FL MIA FROGZ TWO (RNAV) STAR

4-13-22 PRB Results: Returned for Rework

Procedure Review Board (PRB) Results
Florida Metroplex
March 11, 2022

1. **Approval Request:** MIAMI INTL, MIAMI, FLORIDA (MIA) - FROGZ TWO (RNAV) STAR, <https://swims.faa.gov/Procedure/Edit/7372>

FROGZ TWO ARRIVAL (RNAV) Transition Routes

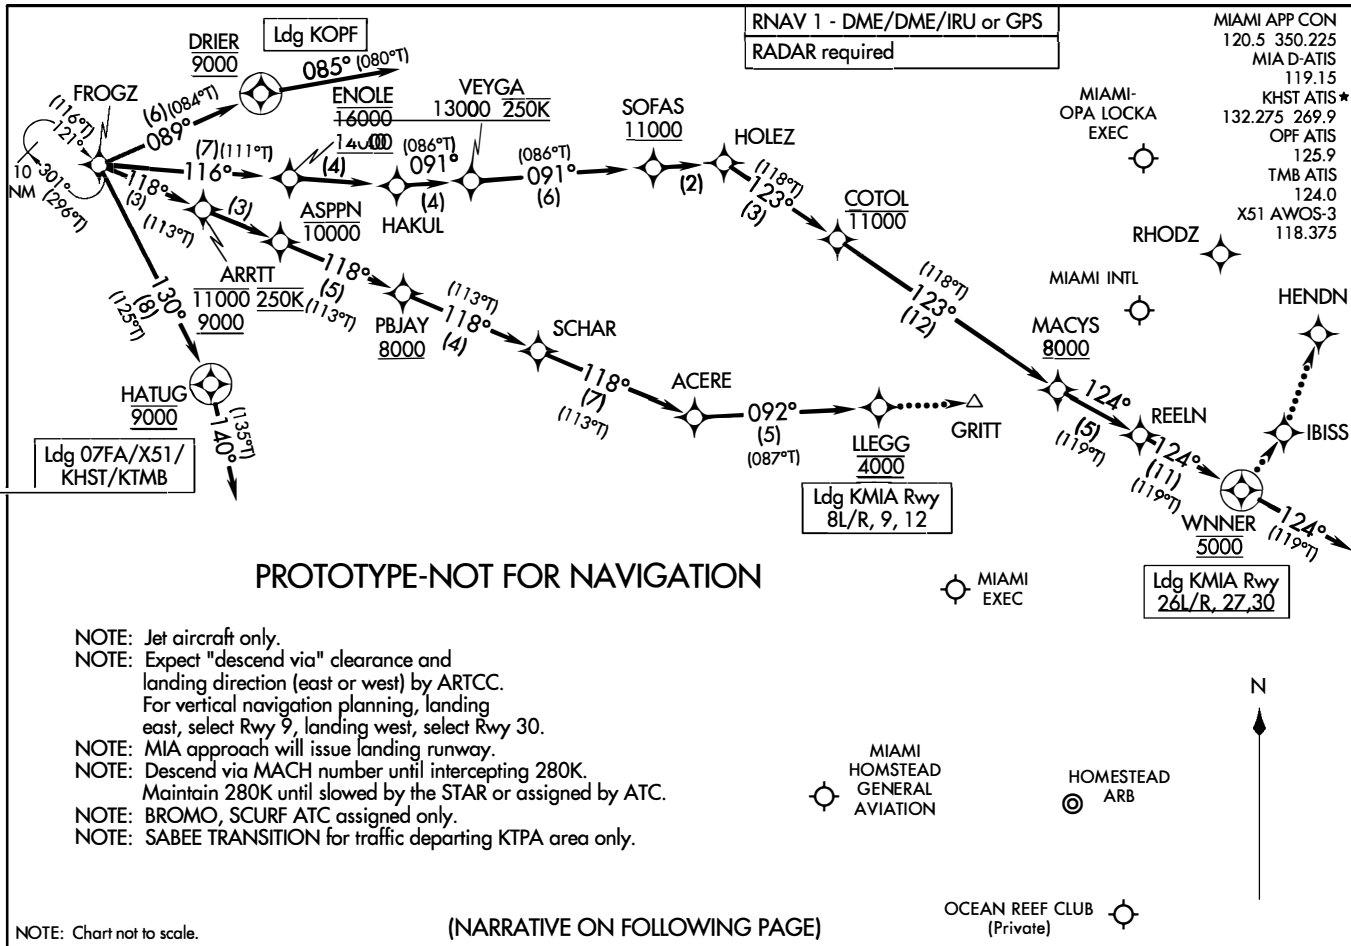
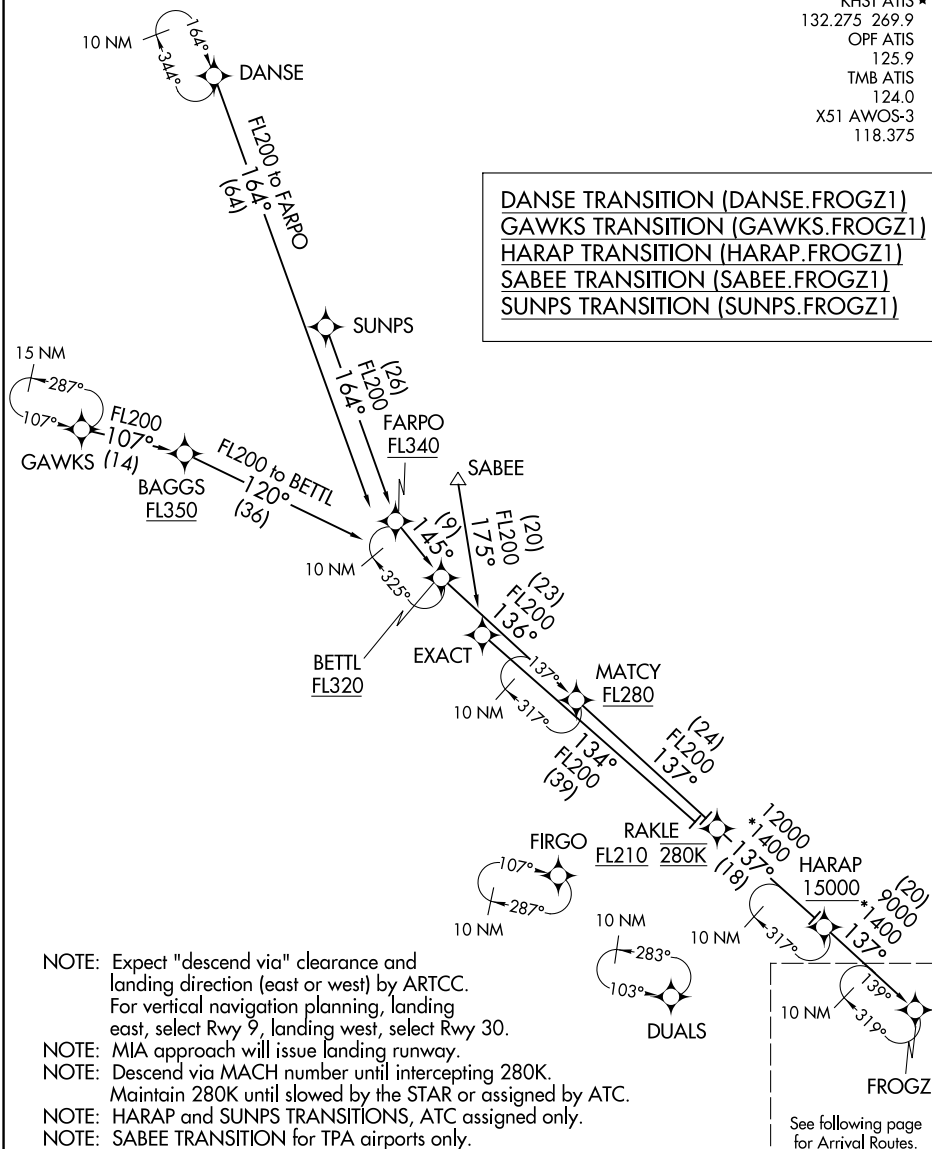
8. IAW 8260.3, para 2-2-2c: The LANDING 07FA/X51/KHST/KTMB and LANDING KOPF arrival routed descriptions do not match what was evaluated. Multiple headings are not allowed. Change 8260-

17.1 ARRIVAL ROUTE DESCRIPTION:

LANDING 07FA/X51/KHST/KTMB: "... THEN ON HEADING 140.00."

LANDING KOPF: "...THEN ON HEADING 085.00."

RESPONSE: CONCUR. FLMP will make necessary changes. COMPLETED

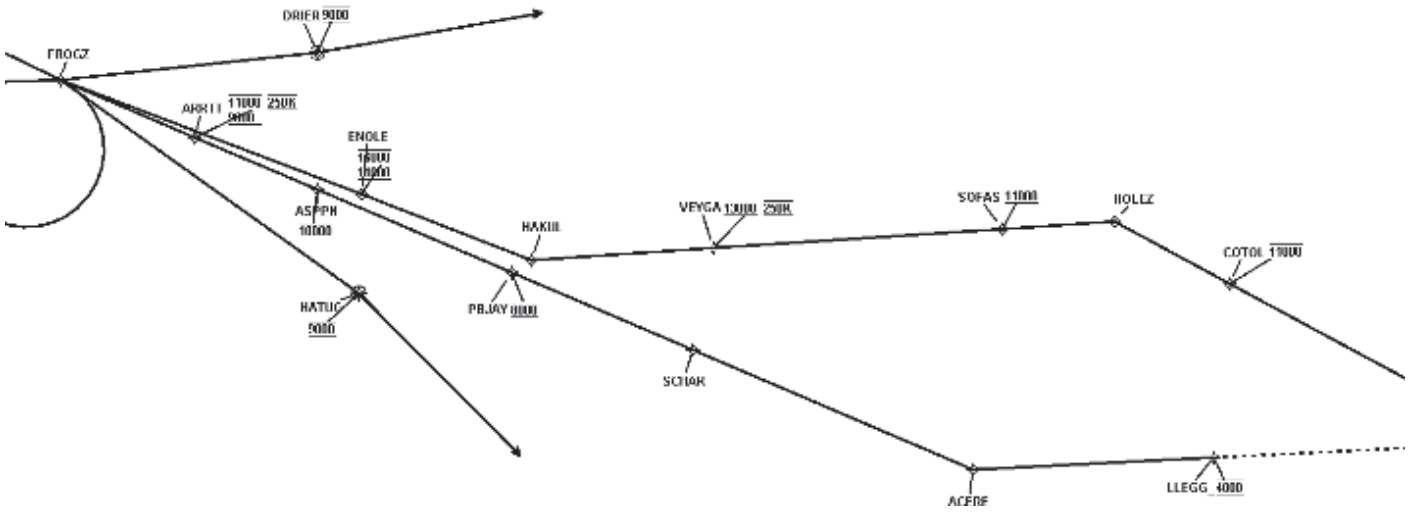
RSO144: [Approval Required] The Descent Gradient (430.22) from ASPPN to PBJAY is greater than the Maximum Permissible Descent Gradient (318.0).

A computed descent gradient value from ASPPN to PBJAY of 430.23 ft./NM resulted from the descent gradient being calculated from descending from the restriction of At or Below, 10000 at ASPPN to cross PBJAY At or Above 8000 over a distance of 4.65 NM. The next restrictions after PBJAY are at MABYB, AOA 7000 and LLEGG at 4000. The distance from ASPPN to LLEGG is 22.96NM and using a descent gradient of 318ft/NM a total distance of 18.87NM is required. Descending at 318 ft. per NM places an aircraft descending from 10000 at ASPPN to cross the restriction at PBJAY of AOA 8000 at 8520, and to cross over MABYB AOA 7000 at 7000 and to cross over LLEGG at 4000. Calculating a descent from ASSPN at 10000 to LLEGG at 4000 distance 23.88nm resulted in a descent gradient of 209.4 ft per NM.

Consideration was given to removing and or changing the restrictions at ASPPN and PBJAY. However, to prevent aircraft from entering adjacent airspace above the FROGZ STAR, the requirement to provide de-confliction from the KFLB BHHIA STAR below the FROGX STAR, and to reduce ATC workload due to required coordination, (point outs) it was decided that the restrictions are necessary.
